STAFF RECOMMENDATION

1112 Montrose Avenue

July 17, 2019

Application: Demolition; New Construction-Infill

Figure 6: Proposed side elevation, dashed line indicates 32 foot height

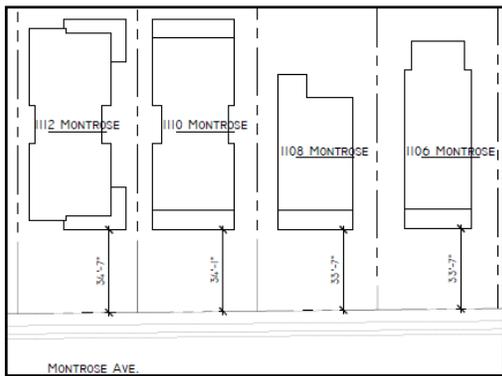
The historic properties in the immediate context are exclusively one and one-and-a-half story houses, with a maximum height of about twenty-five feet (25') from grade. The two houses to the immediate right of the site, #1108 and #1106 Montrose are both about twenty feet (20') high as measured from grade to the peak of each side-facing gable.(Figures 3 & 4). When measured at the same point, the proposed infill is about thirty-two feet (32') tall. (Figure 6)

Staff finds that the proposed height is inappropriate for the context. Based on examples in the immediate context, an appropriately scaled one-and-a-half story house on this block would be a maximum of twenty-five feet (25') tall.

With the condition that the overall height is reduced to a maximum of twenty-five feet (25') tall, the eave height is reduced to a maximum of twelve feet (12') high and the foundation height is reduced to meet the historic context, staff finds that the project meets section III.A for height.

CONTEXTUAL
 SITE PLAN

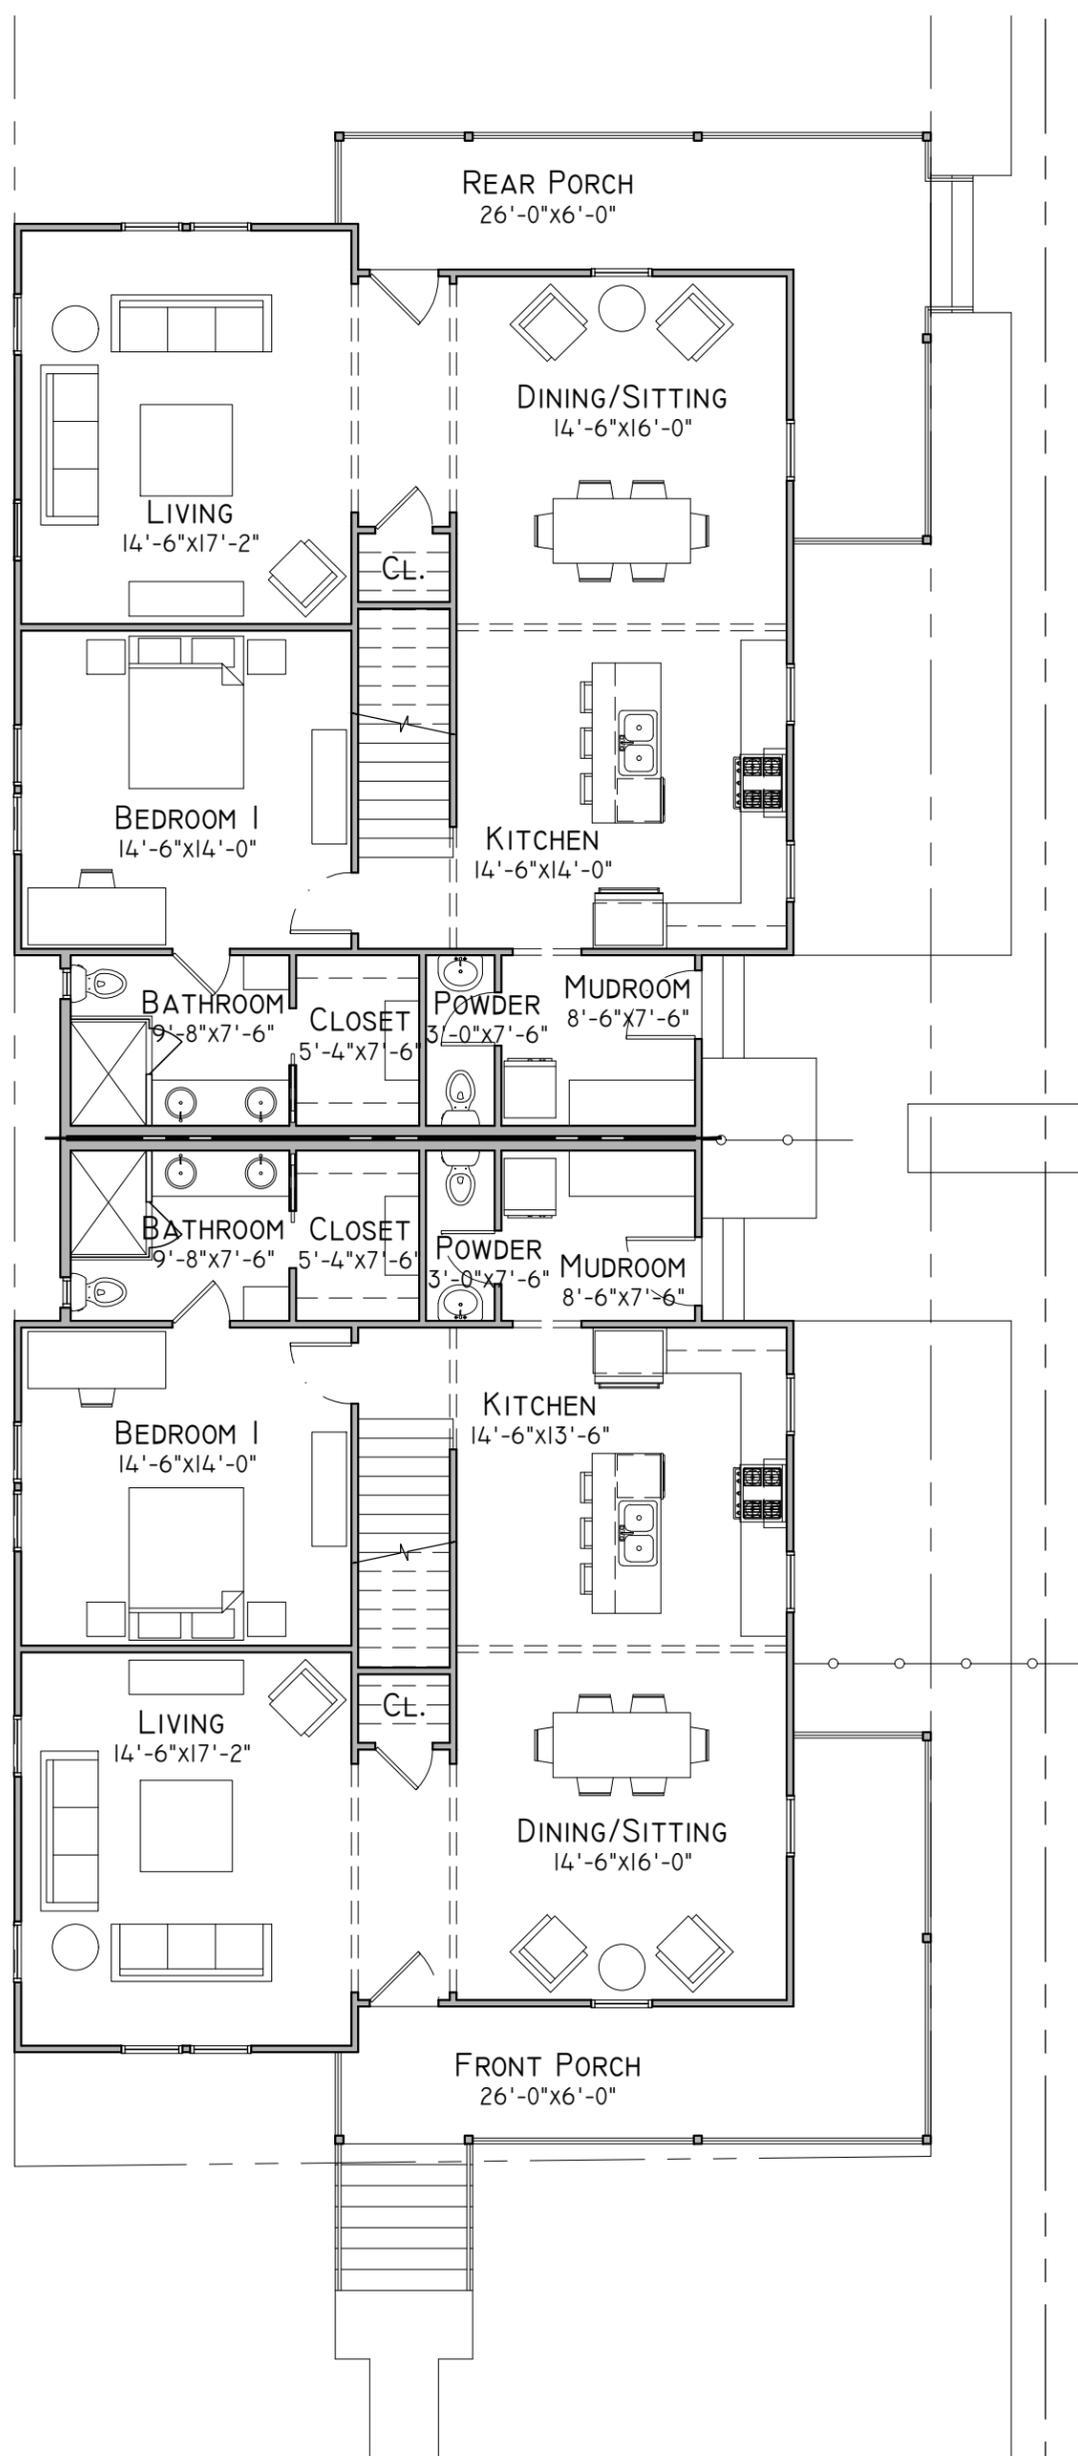
The front setback is indicated to be about thirty-four feet, seven inches (34'7"), which is consistent with the historic house next door, at 1108 Montrose Avenue. It appears to be about one foot (1') off, but this is due to the gently angled front lot lines. The intent is to align the front setback with that of the historic house at #1108 Montrose and the infill at 1110 Montrose. As always, staff will verify the appropriate setback in the field at staking.

1110 + 1112
MONTROSE
ELEVATIONS

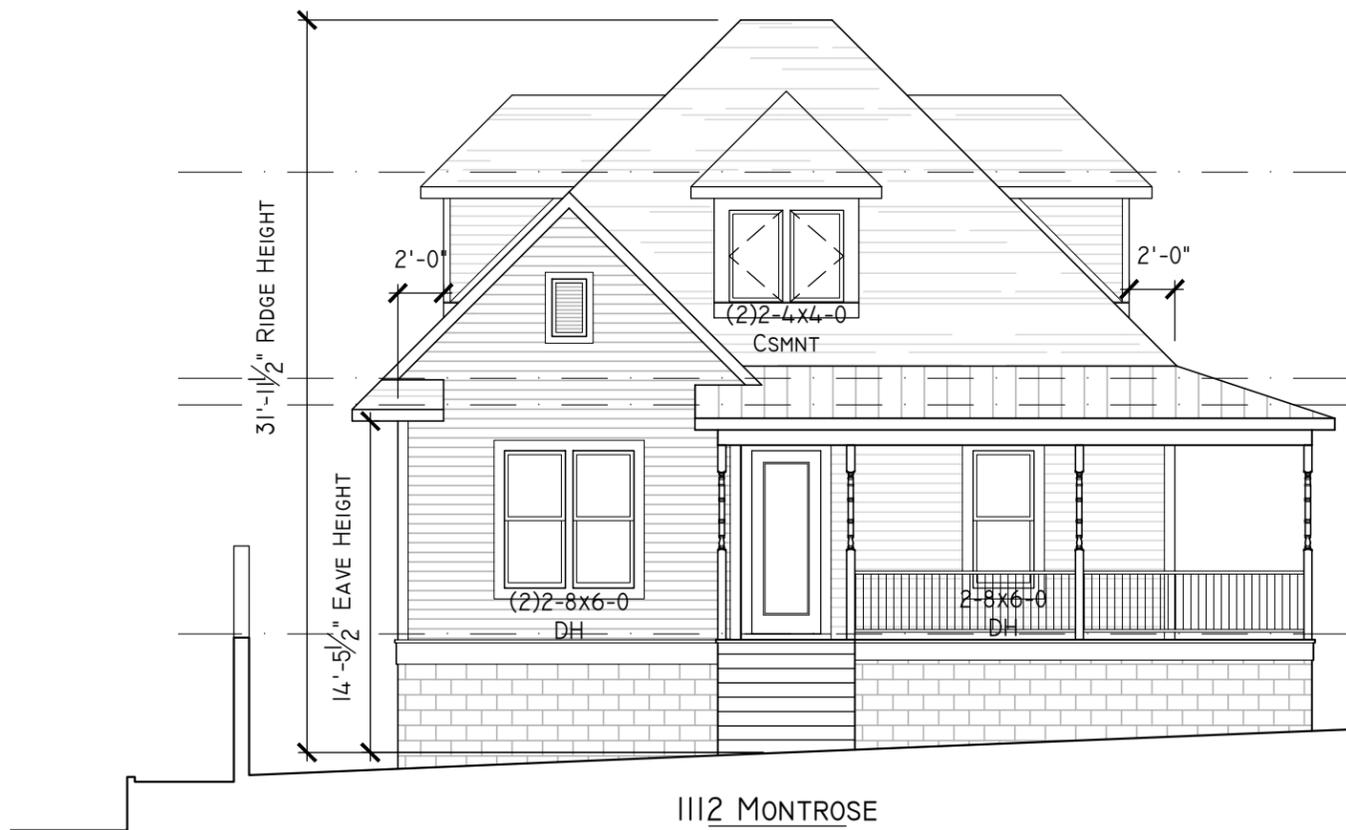
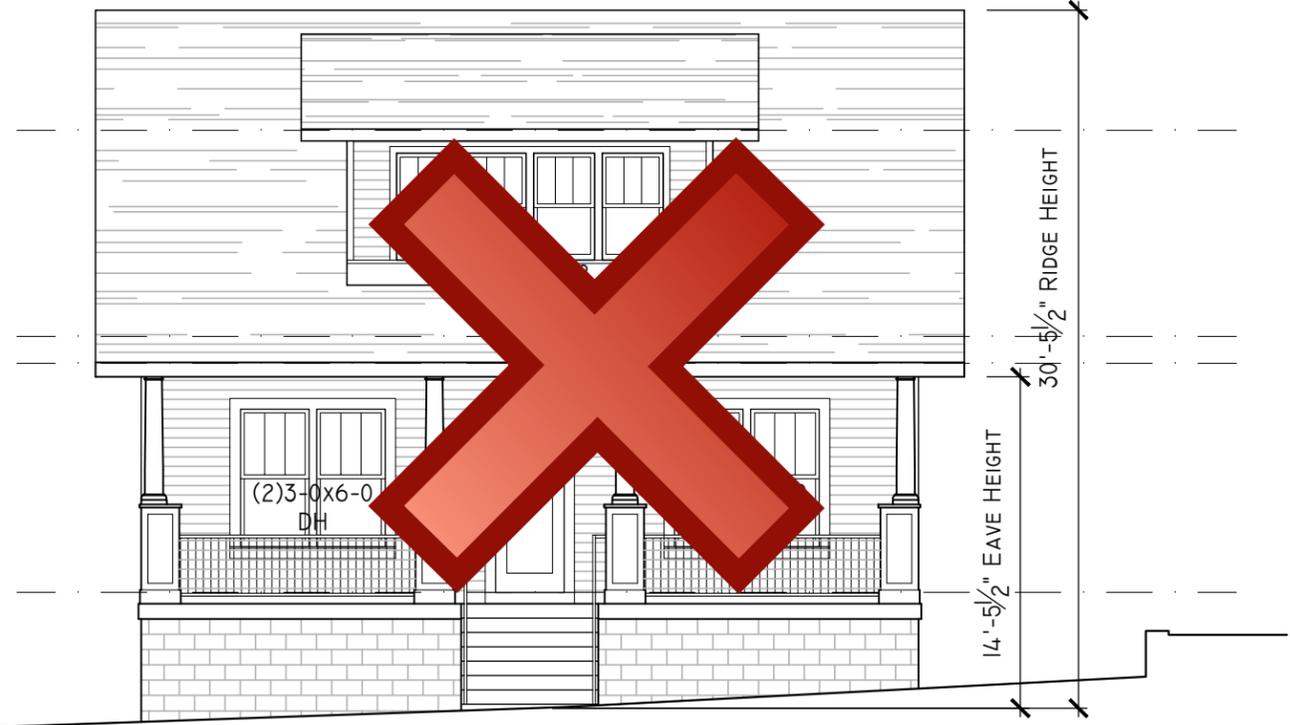
The tallest historic house on the block stands across the street from the proposed infill at 1109 Montrose. This house, measured at the same point, is about twenty-four feet (24') tall. (Figure 5) Further, the proposed infill has a foundation height in the front of nearly five feet (5') at its highest point. The foundation height on 1106, 1108 and 1109 Montrose is two feet (2'). The foundation height should match the historic context and will be field checked by Staff. (Figures 3-5)

The proposed width of the infill is thirty-four feet (34'). The historic houses on the block average about thirty-one feet (31') wide, however the house at 1102 Montrose Avenue is about thirty-three feet (33') wide and the one at 1103 Montrose is about thirty-six (36') wide. Therefore, staff finds that the proposed thirty-four foot (34') width could be appropriate.

3. The finished floor height shall be consistent with the finished floor heights of the adjacent historic houses, to be verified by MHZC staff in the field;
4. Staff shall approve the front setback in the field at staking;
5. Staff shall approve the roofing color, porch materials, windows, doors and driveway and walkway materials prior to purchase and installation; and,
6. The HVAC shall be located behind the house or on either side, beyond the midpoint of the house, and utility meters shall be located on the side of the building, within five feet (5') of the front corner or on the rear or rear-side within five feet (5') of the rear corner. Alternative mechanical and utility locations must be approved prior to an administrative sign-off on building permit(s),

1112 MONTROSE ELEVATIONS

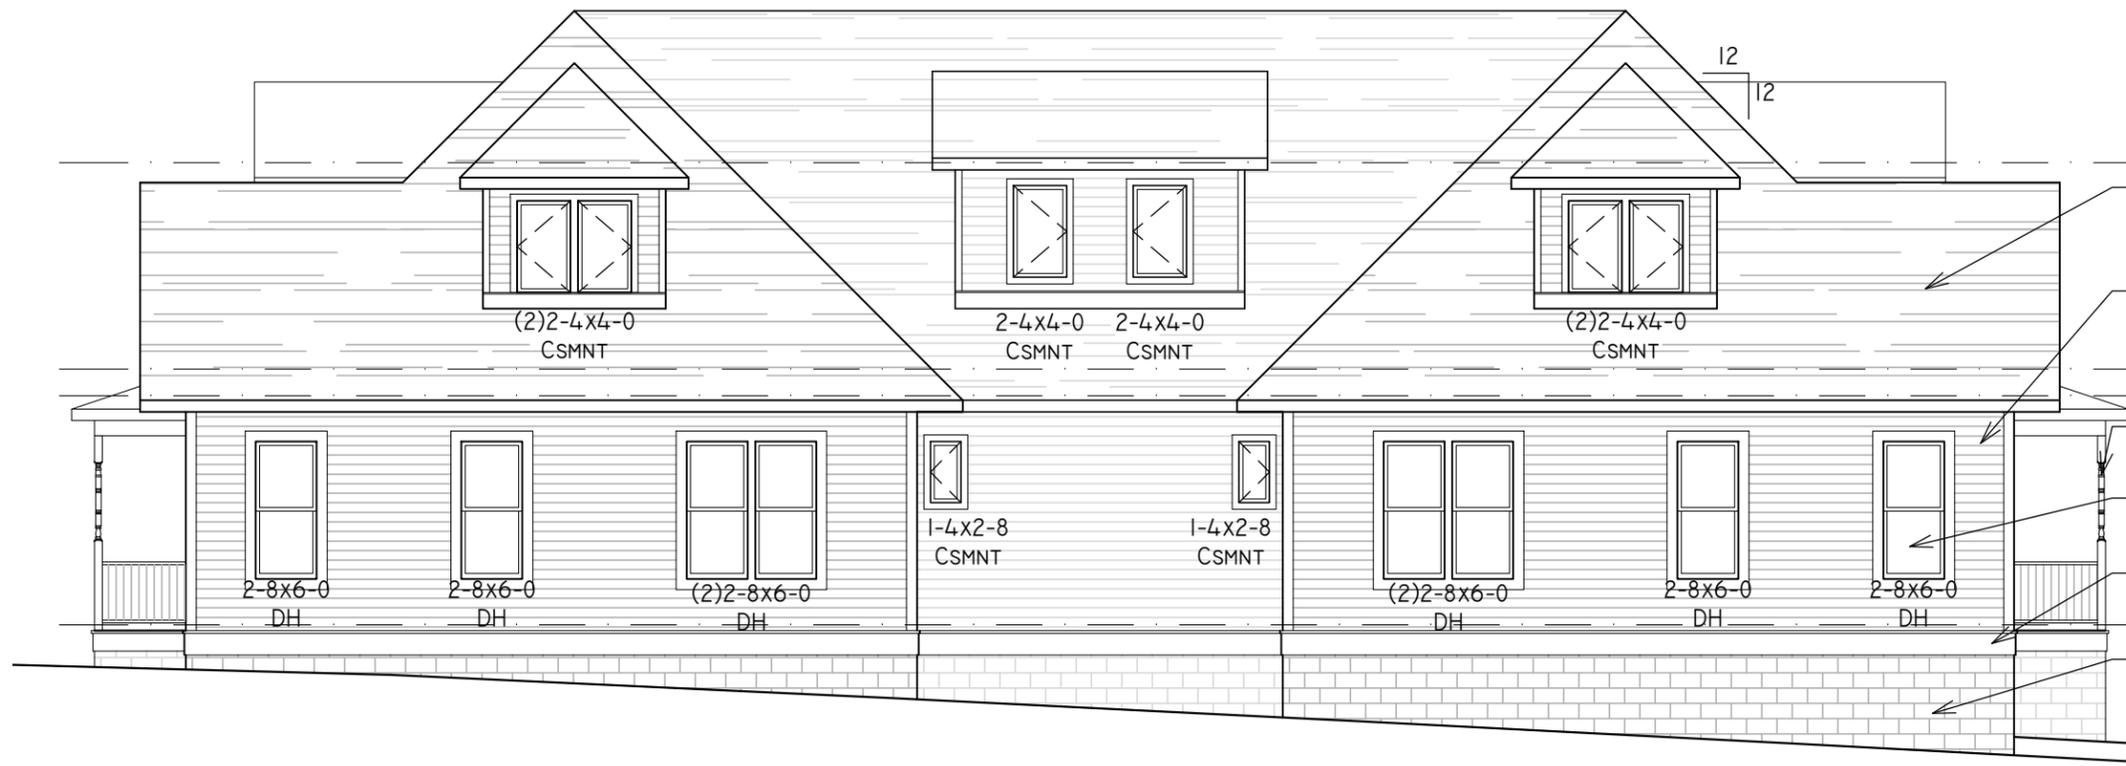
The eave heights of the proposed house are about thirteen feet to fourteen feet, five inches (13'-14'5") high at the front. The eave heights of the nearby historic houses are from ten to eleven feet (10'-11') high. Staff finds that the eave heights are too tall and recommends that they be reduced to no higher than twelve feet (12').

1. The overall height shall not exceed twenty-five feet (25') high;
2. The eave height shall not exceed twelve feet (12');
